ROOF REPLACEMENT CAPITAL PLAZA

FRANKFORT, KENTUCKY

REVISION NO. 1 11 APR. 2005

"AS-BUILT" NOTE:

AREA PLAN 1' = 20' - 0" (SHOWING PANELS TO BE REMOVED) NORTH

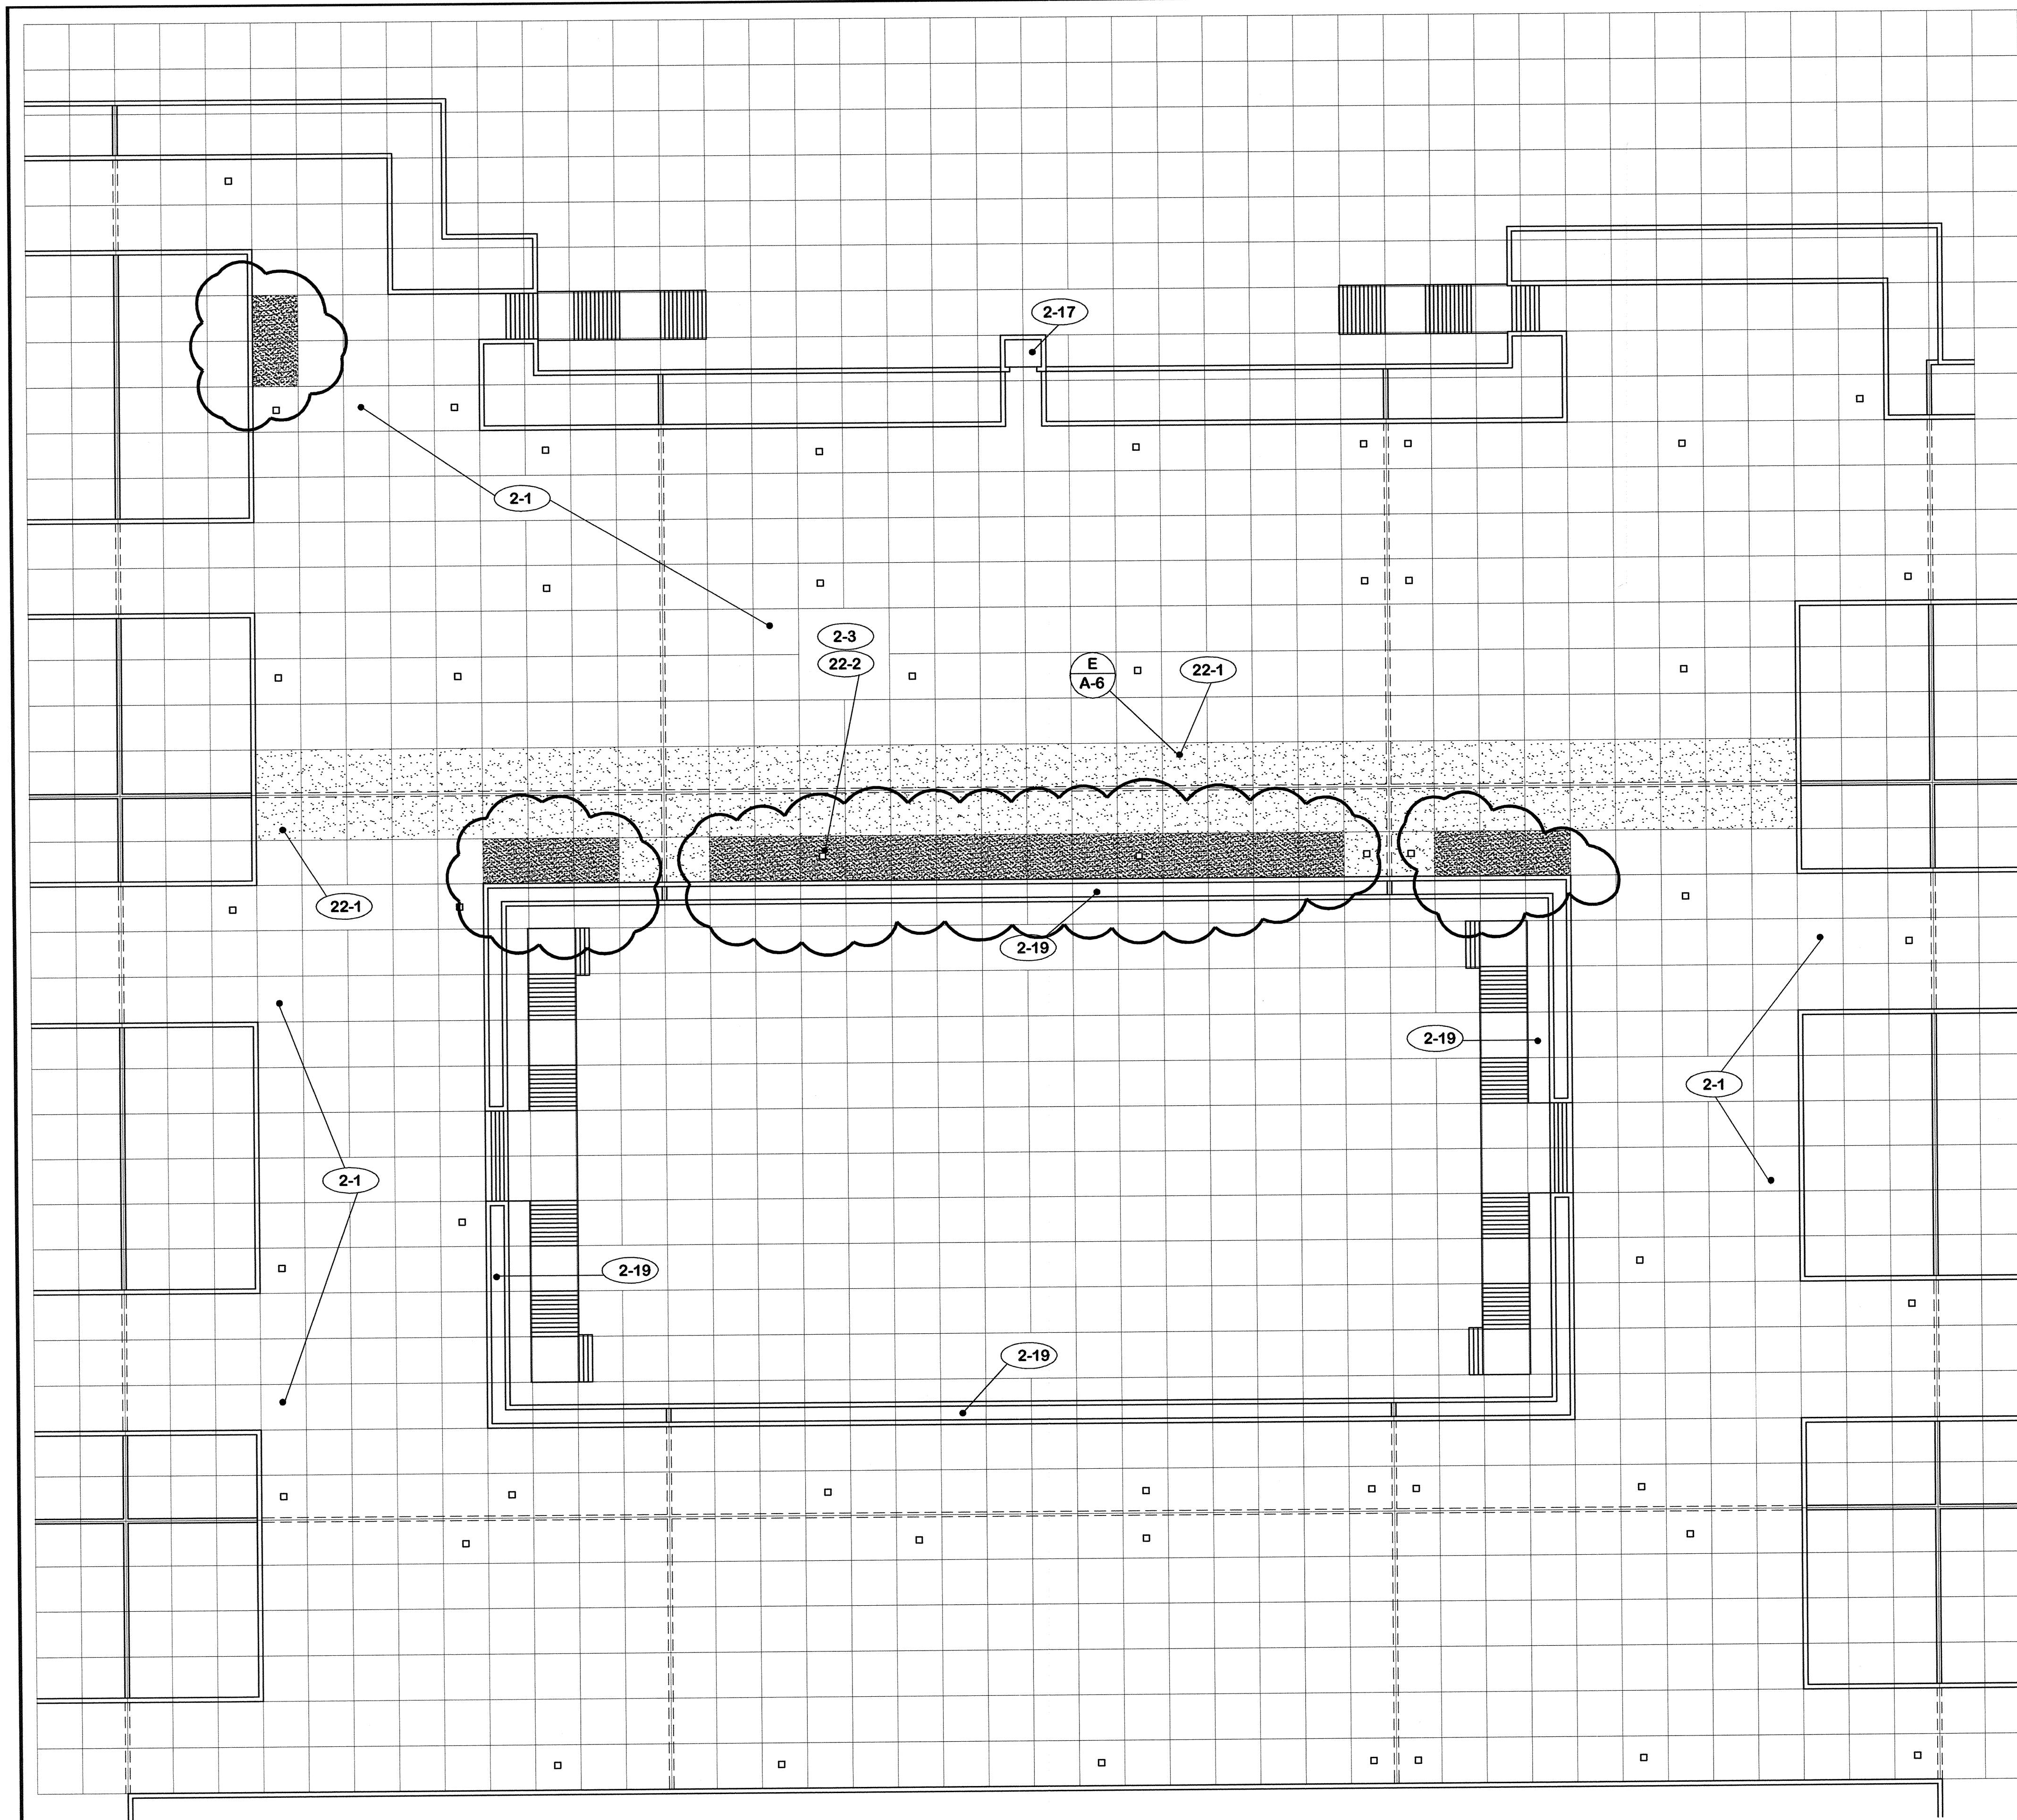
1. Added panels to drawing included in addendum No. 1.
2. Delete note 21-4.
3. See revised panel layout sheet A-10.

ROOF PLAN 1" = 20' - 0" NORTH

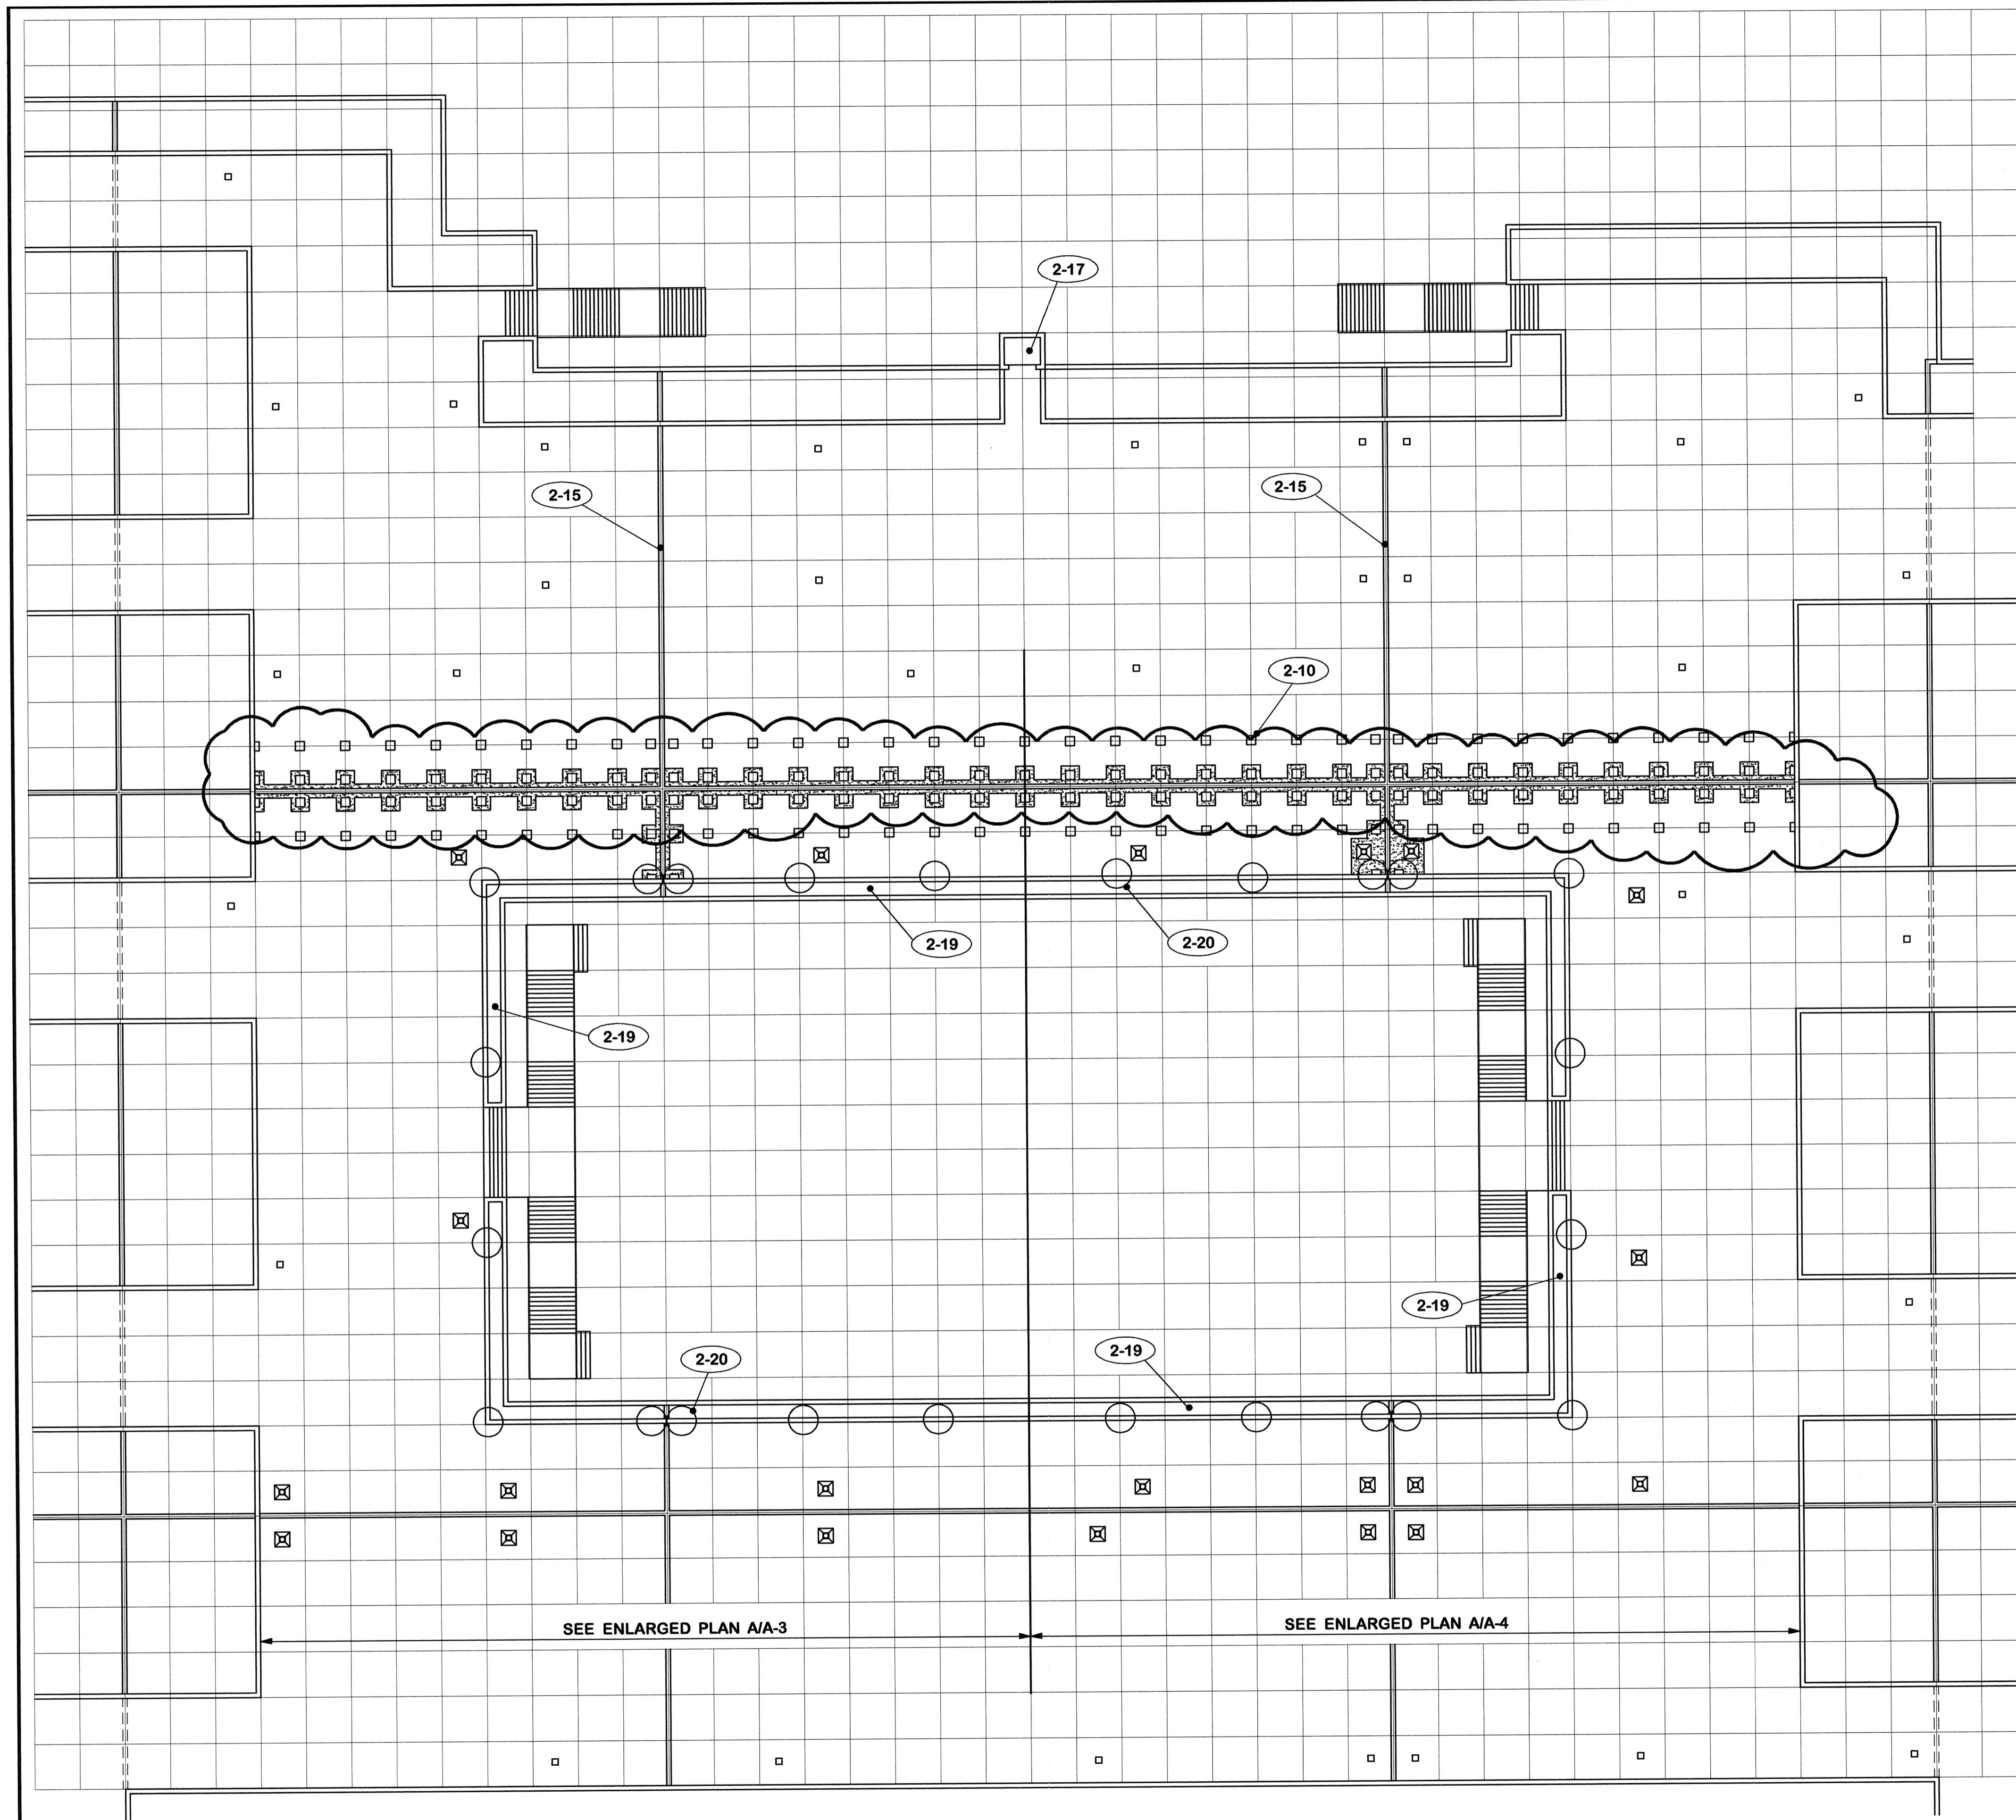
1. Revised work required at expansion joint. See sheet A-11.
2. Added note 21-4.

PLAN **A** 3/32" = 1' - 0" NORTH HALF OF CONSTRUCTION AREA NORTH

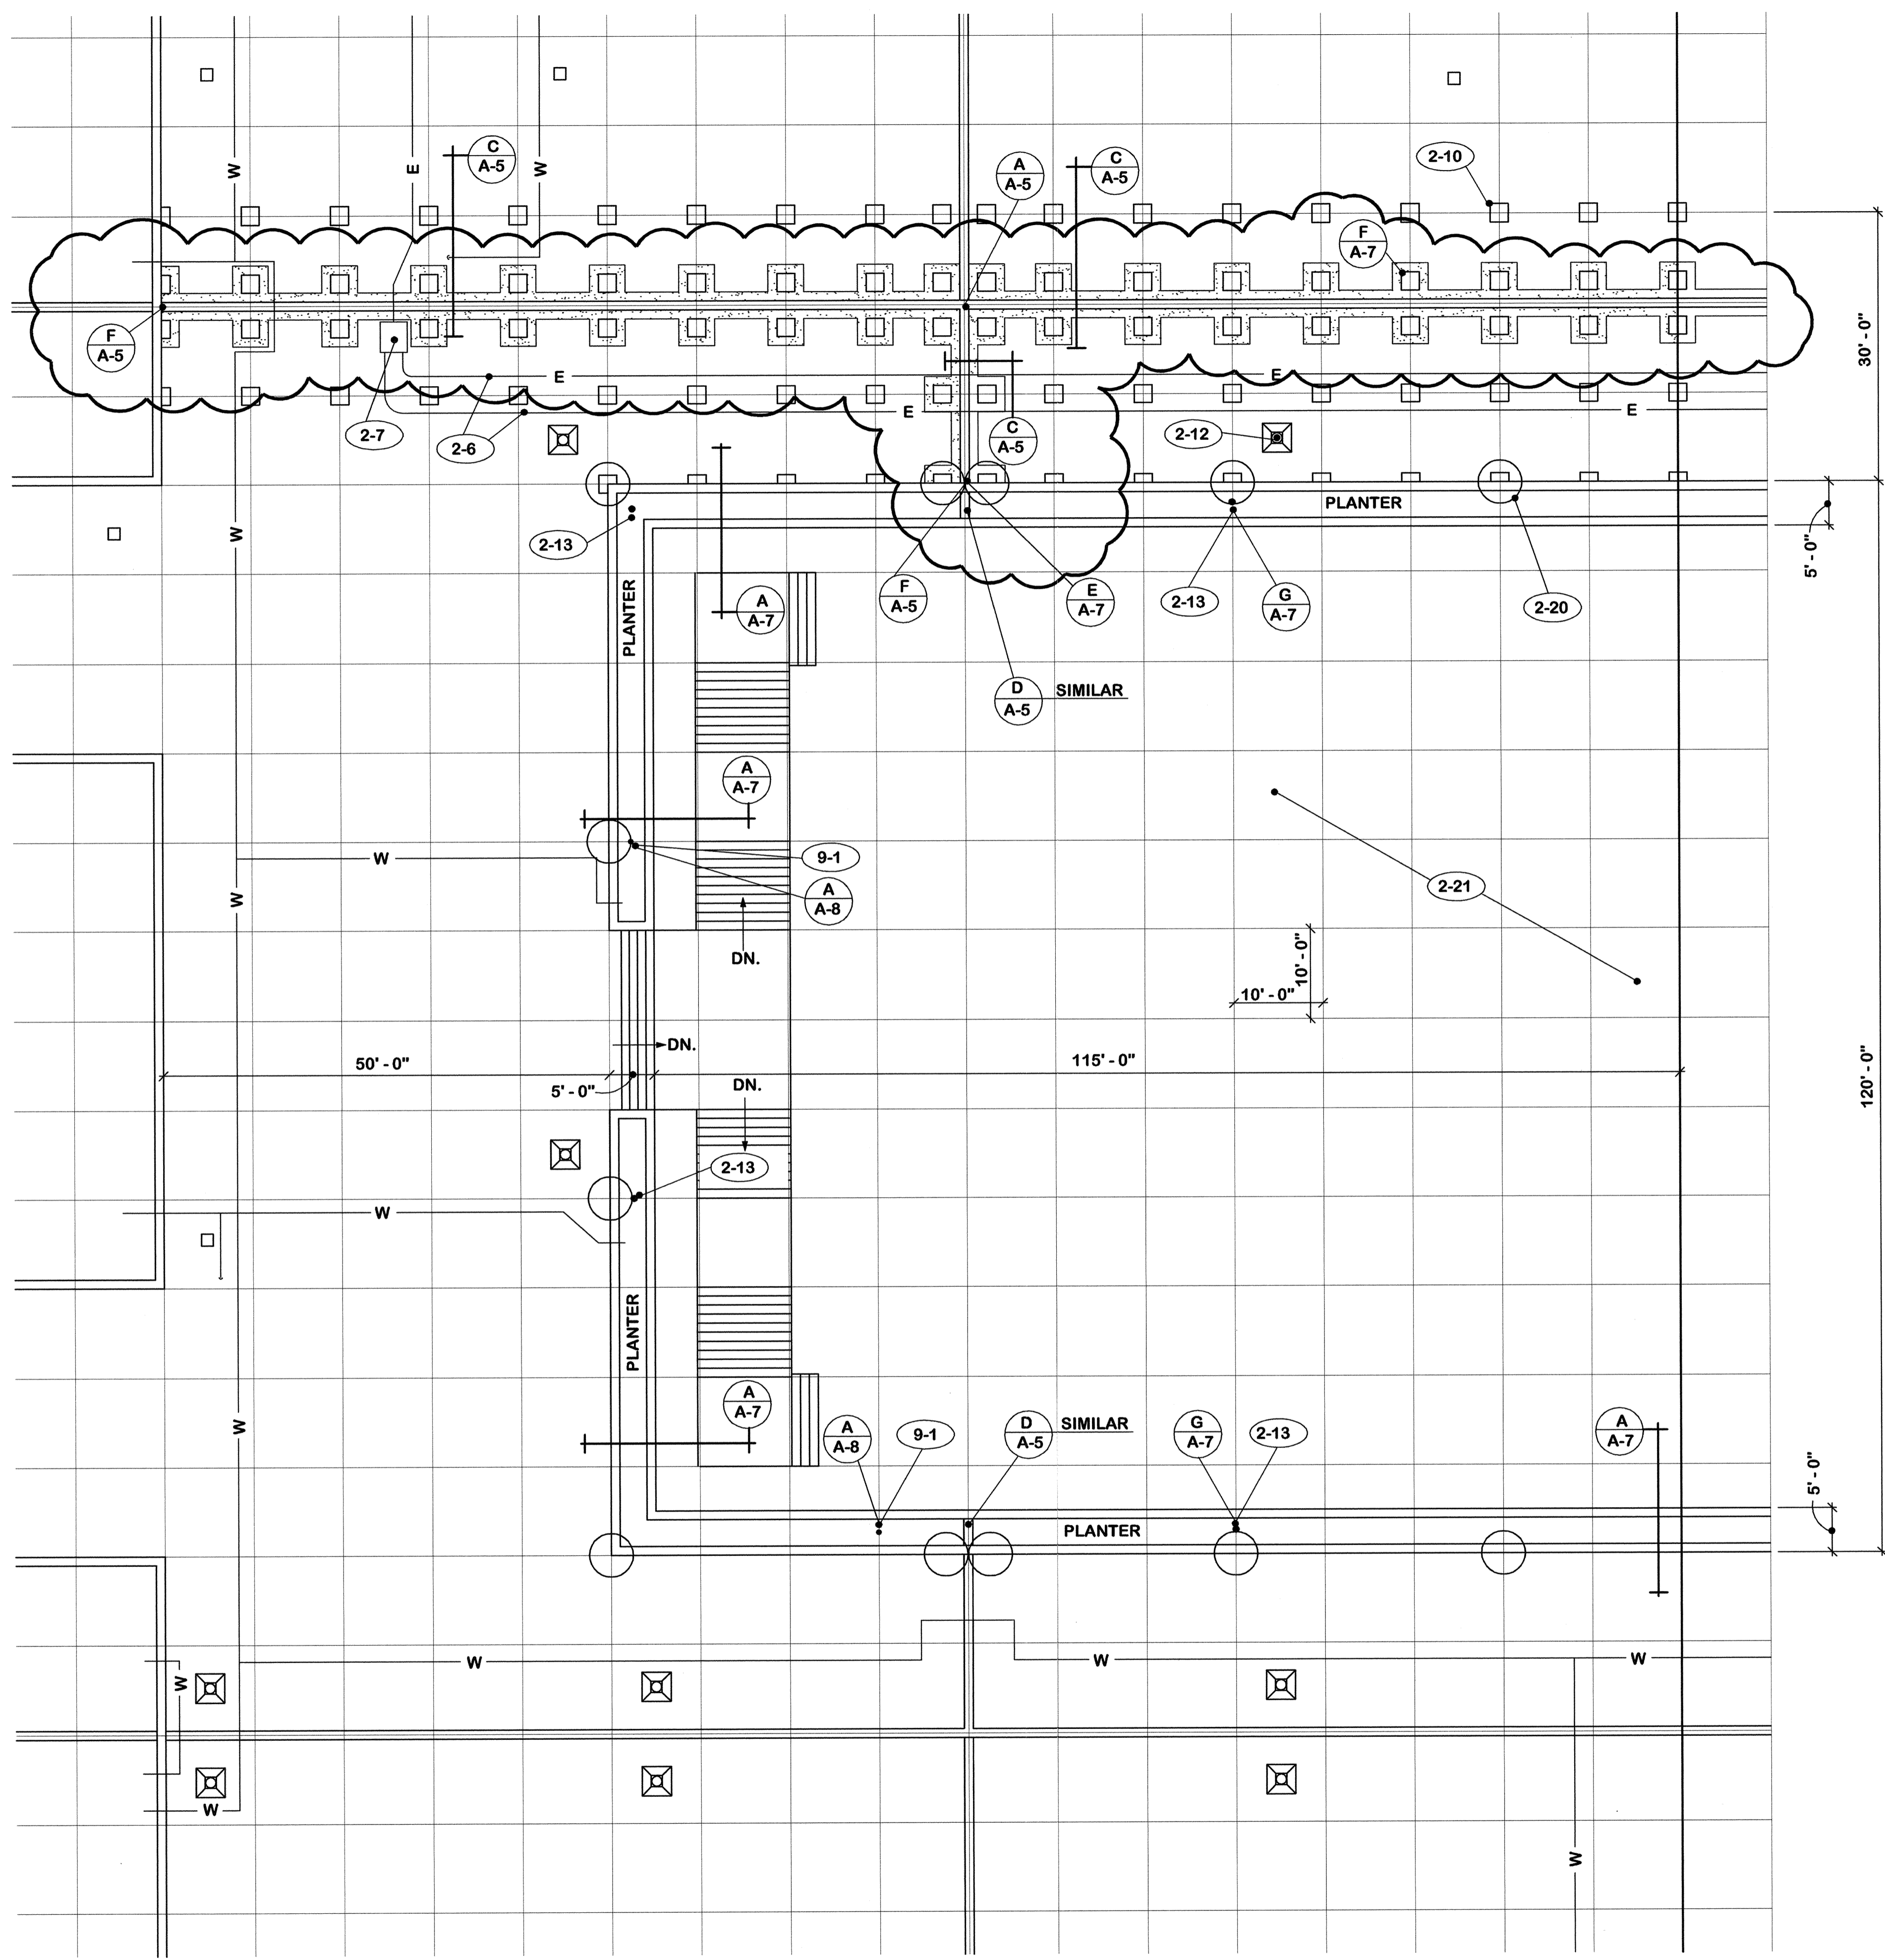
1. Revised work required at expansion joint. See sh. A-11.
2. Added note 21-4.
